FMB125 Product Change Notifications

Product change notifications (PCN) is the way of informing customers of upcoming changes related to Teltonika products. This includes outward appearance adjustments, hardware improvements, firmware changes, changes to package contents, etc. This page stores information regarding changes to the FMB125 tracking device. Below you will find a list of both upcoming and already implemented changes sorted from newest to oldest (top to bottom).

2021.01.01: Top Laser Printing Changes

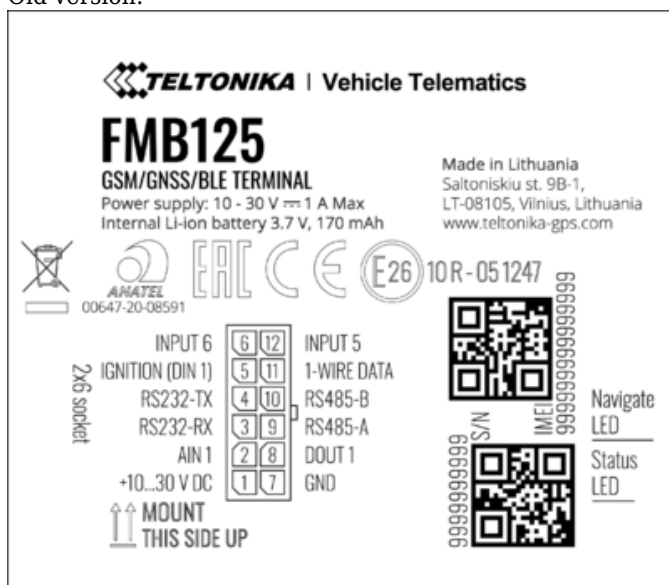
We would like to inform you, that laser printing of the FMB125 device was updated in the factory in January 2021.

Change type	External/visual
	Top laser printing design changed
	Old version:

Change reasons	1. Updated Emark certificate number. 2. Added UKCA label. 3. Updated Teltonika brand to Teltonika Telematics.
----------------	---
